STATE OF NORTH CAROLINA  
DEPARTMENT OF TRANSPORTATION

January 21, 2009

Subject: **Modification for Individual Section 404 and to Individual 401  
Certification for Section R-2518A**  
For US 19/US 19E Improvements  
From US 19/23 to SR 1421 (Windy Gap Road)  
Yancey County  
NCDOT Division 13  
State Project Numbers 6.869005T and 6.909001T  
T.I.P. Project Number R-2518A  
Debit \$570.00 from WBS Element 34634.1.2

FOR -L- PROFILE SEE SHEET 59  
 Permit Drawing  
 Sheet 58 of 64  
 REVISED PERMIT DRAWING  
 11/21/09

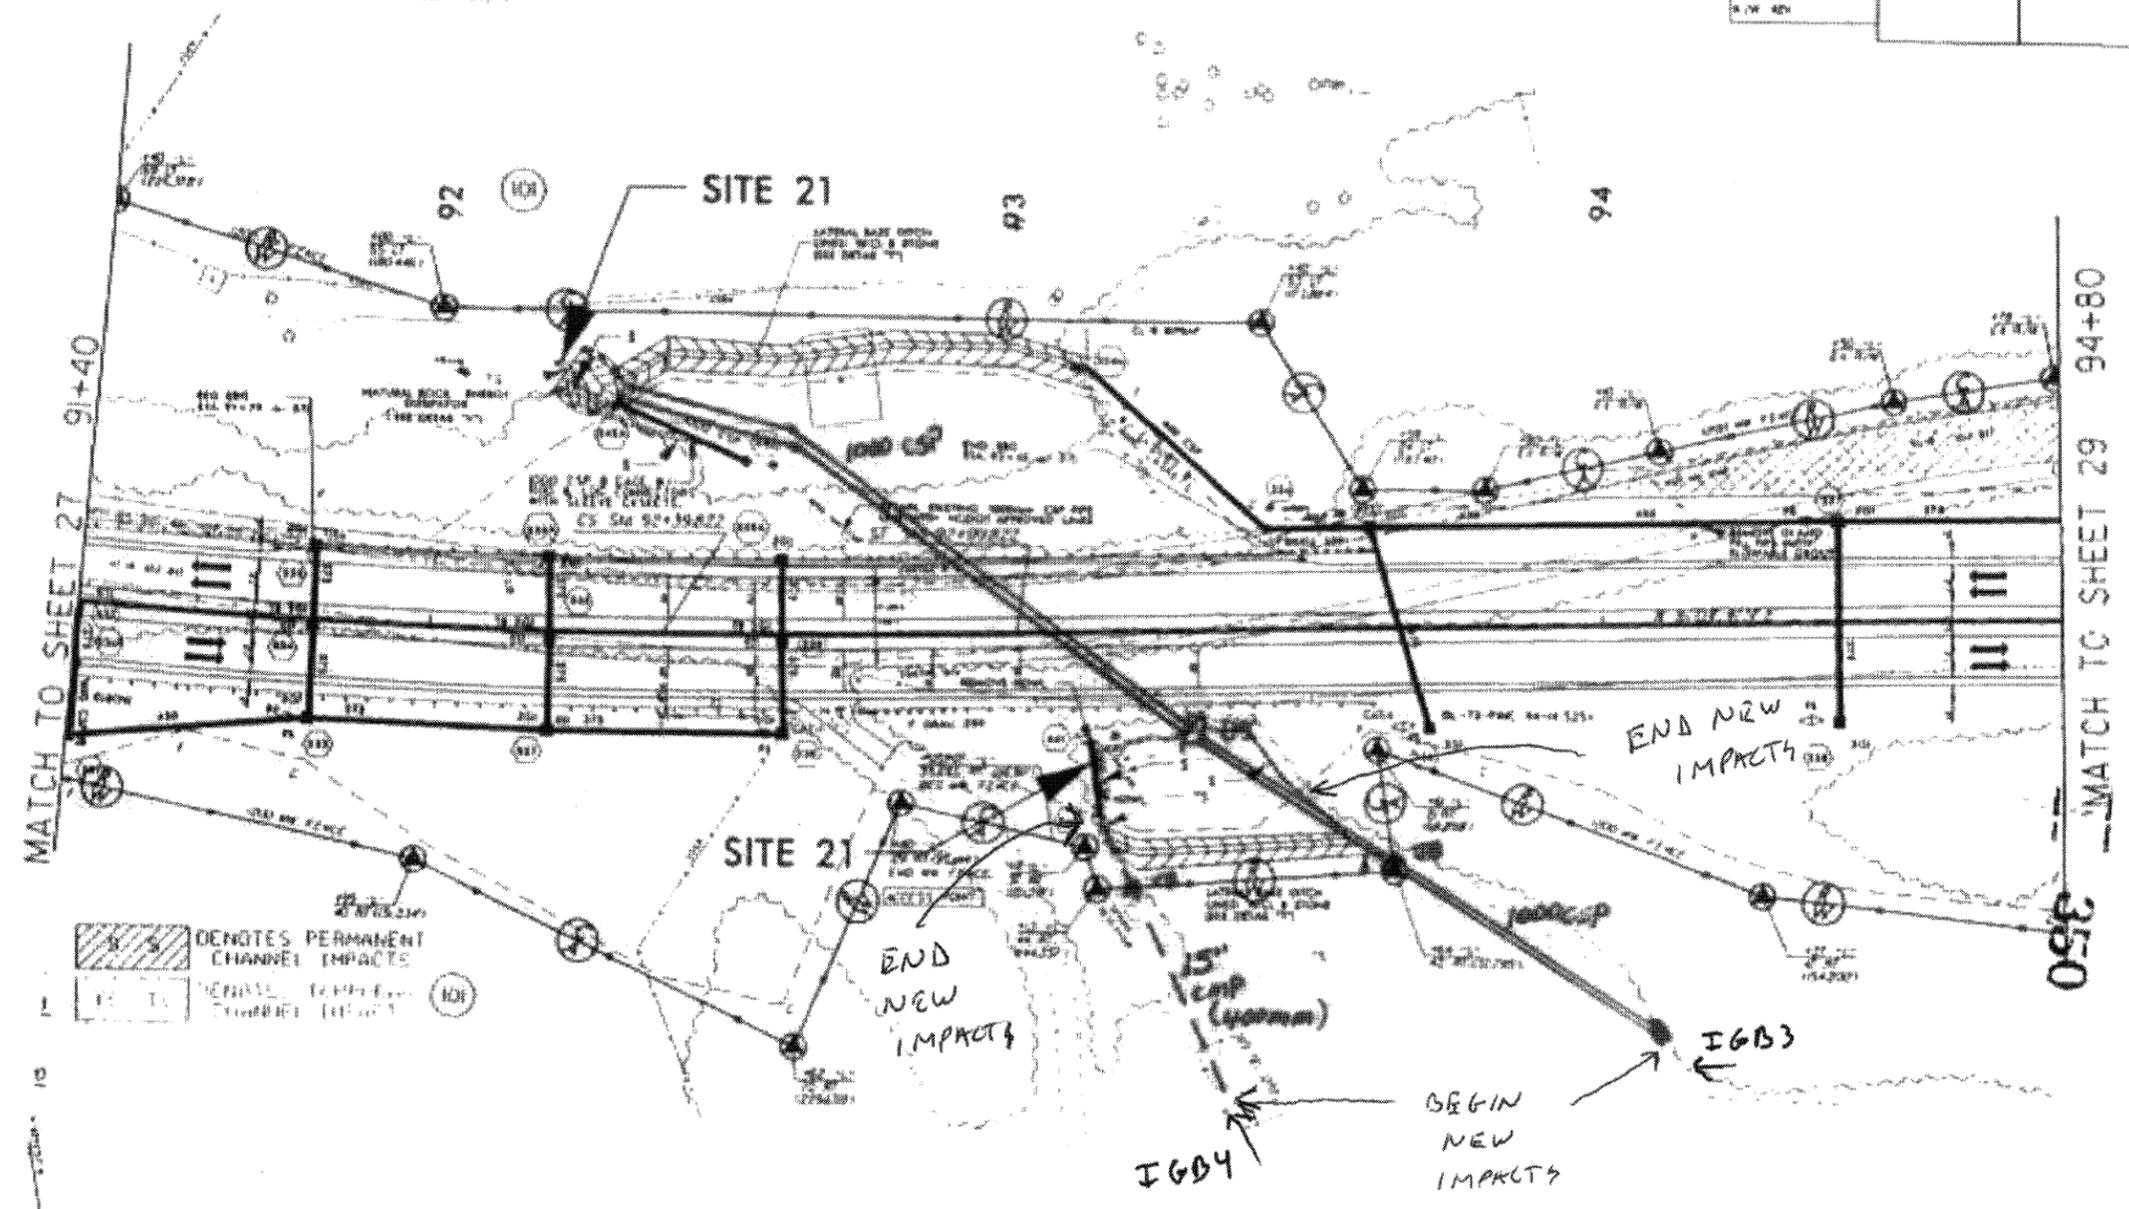
This letter addresses modifications to Section R-2518A of the 19E Widening Project that extends from US 19/23 to SR 1421 (Windy Gap Road) in Yancey County. The North Carolina Department of Transportation (NCDOT) requests approval for revisions to the above referenced permits. Site 21 on Permit Drawing Sheet 58 (the Revised Permit Drawing Sheet 58 is attached) from the Individual permit issued April 1, 2008 depicted impacts to two unnamed tributaries to Ivey Gap Branch (labeled IGB3 & IGB4 on the attached Revised Permit Drawing Sheet 58). IGB3 was proposed to be impacted by roadway fill and IGB4 was proposed to be impacted by extension of a 1050 mm reinforced concrete pipe with total impacts of 325 linear feet (lf). Upon investigation it was found that the existing 1050 mm pipe was damaged and installing a liner to repair it caused a reduction in hydraulic capacity. Therefore, a new 1000 mm corrugated steel pipe is proposed to be installed to the north of the existing pipe and will line up with IGB3. The existing pipe will still carry IGB4. The new 1000 mm pipe will extend to match the grade of IGB3 which will result in 170 lf of additional permanent impacts to this stream. The fill line will be extended to cover the new pipe causing the existing 1050 mm

pipe to need a longer extension for IGB4. A new 400 mm corrugated metal pipe will extend from the proposed extension on the existing pipe resulting in an additional 215 lf of permanent impacts to IGB4. Site 21 will then have an additional 385 lf of permanent impacts added to the previously proposed 325 lf of permanent impacts for a total of 710 lf of permanent impacts to surface waters at this site. No new temporary impacts to surface waters will result from this action. The need for these modifications was shown to Mike Parker, regional representative for the North Carolina Division of Water Quality at a January 6, 2009 onsite meeting with NCDOT.
